MISSISSIPPI POWER & LIGHT COMPANY

October 14, 1982

SUBJECT: Grand Gulf Nuclear Station
Unit 1
Docket No. 50-416
License No. NPF-13
File 0260/L-350.0/0092
Comments and Status on Grand Gulf
Operating License and Safety
Evaluation Report
AECM-82/358

MP&L OPERATIONAL QUALITY ASSURANCE PROGRAM
ORGANIZATION FIGURE 17.2-1

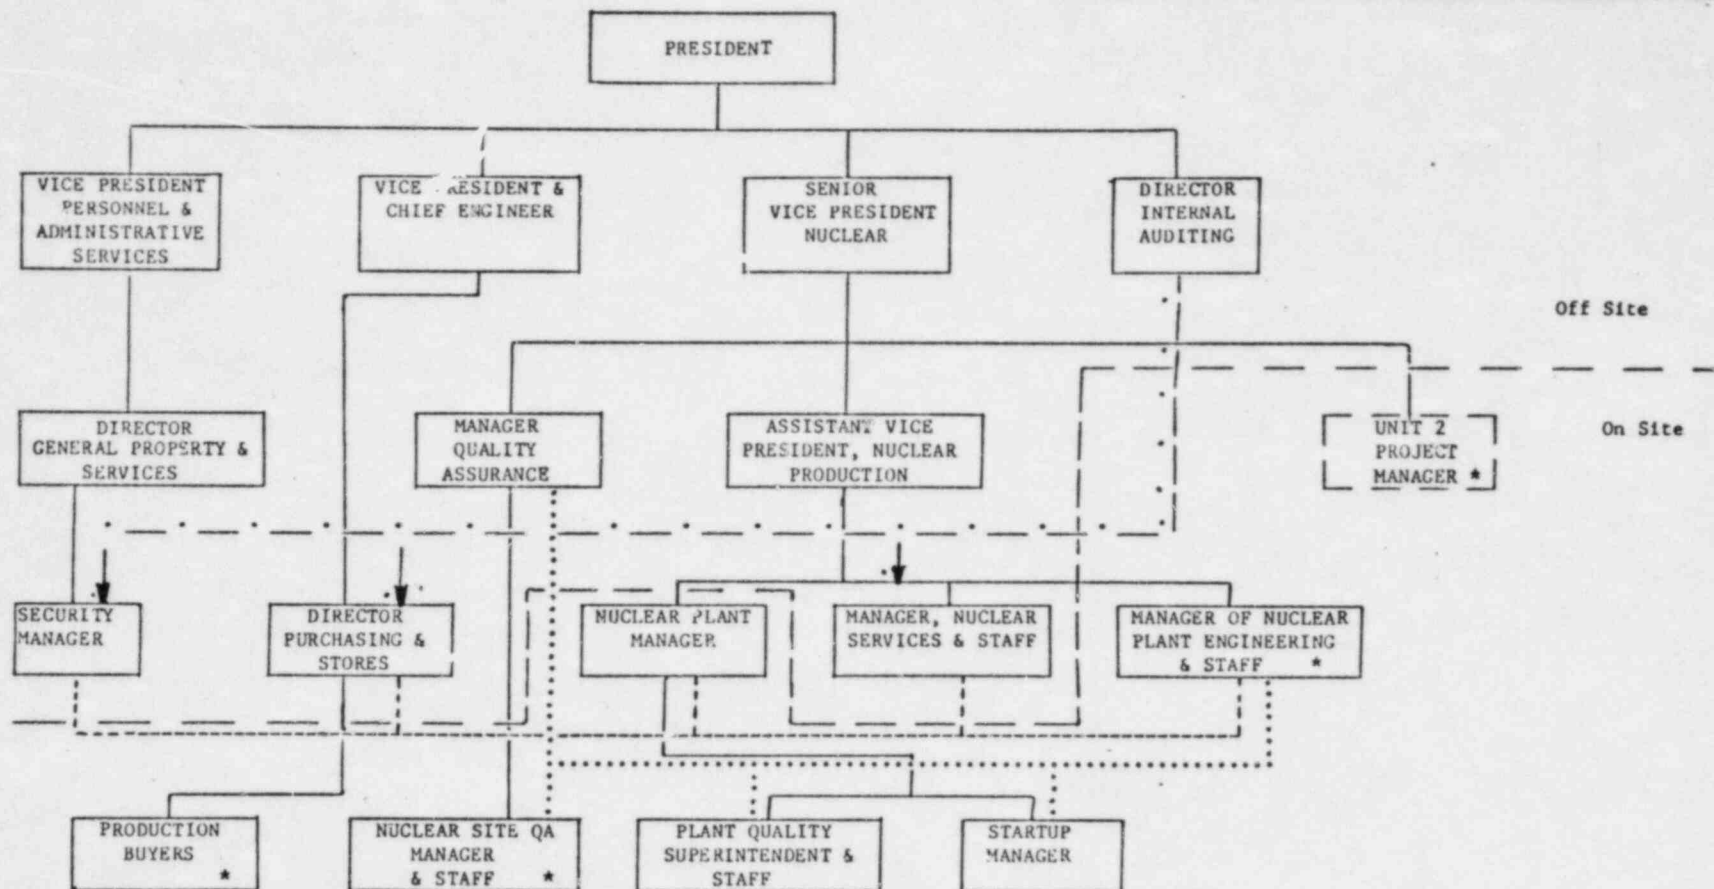
Attached for your consideration is a proposed revision to SER Chapter 17. This revision is provided to clarify the organizational and programmatic policies outlined in MP&L's Operational Quality Assurance Manual, MPL-TOP-1A, which has been accepted by the NRC.
